Subject: AP1000 Response to Request for Additional Information (SRP 3)

RAI-SRP3.8.3-SEB1-05 R4  
RAI-SRP3.8.3-SEB1-07 R2

RAI Response Number: RAI-SRP3.8.3-SEB1-05  
Revision: 4

RAI Response Number: RAI-SRP-3.8.3-SEB1-07

Revise Figure 3.8.3-15 as shown in the attached mark-up (Page 36).

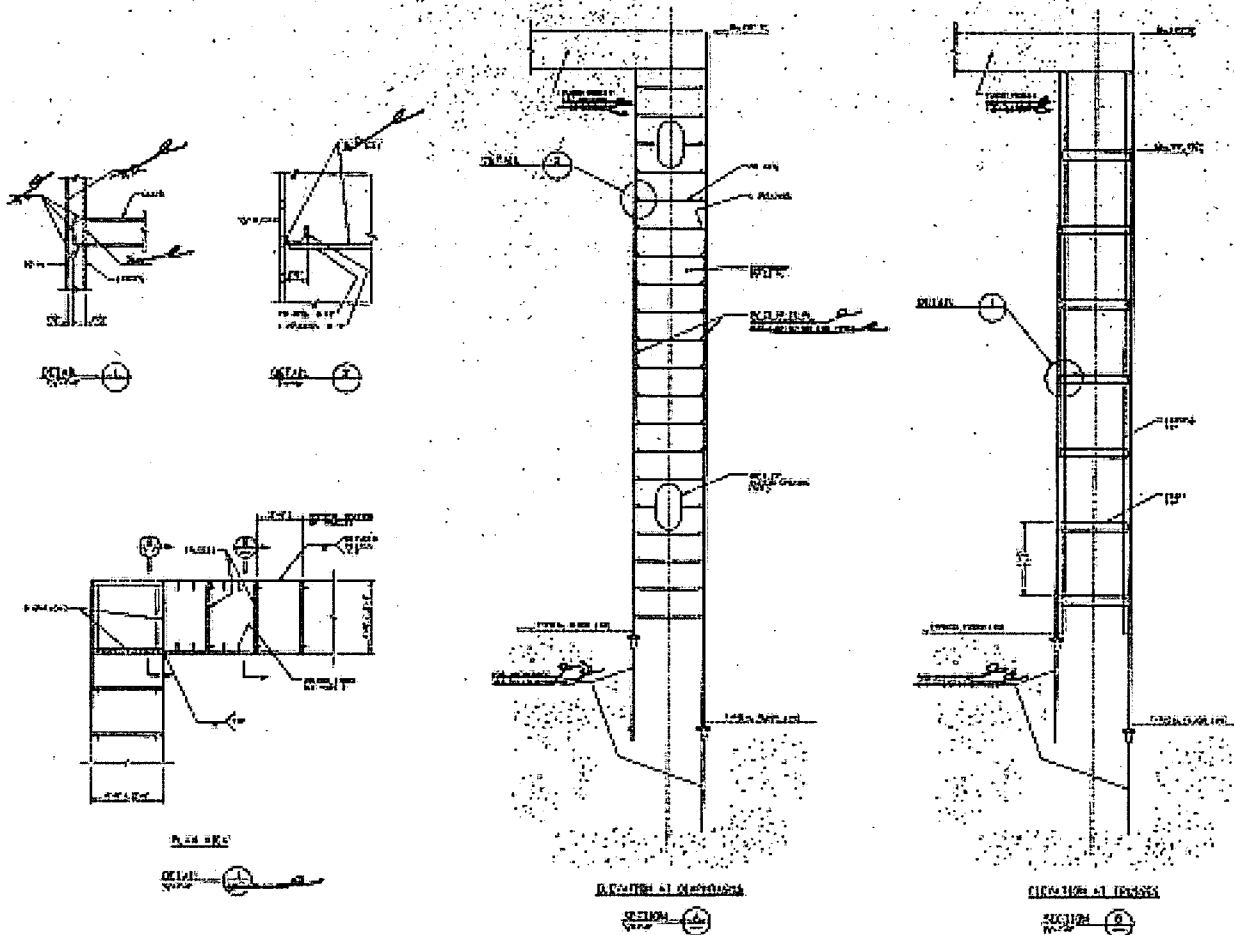
Revise Figure 3.8.3-8 as shown in the attached mark-up (Page 35).

Changes to figure include: Weld Details are removed. References to AP1000 drawings are removed. Note for weld stud spacing is corrected to read as follows:

$\frac{3}{4}\frac{5}{8}$  dia. X 6" @ 6"10" HORIZONTAL FOR SS

Changes to figure include: Weld details are removed. Reference to Nitronic 33 is removed. Diameter of Weld Stud is changed from  $\frac{3}{4}$  inch diameter to  $\frac{5}{8}$  inch diameter.
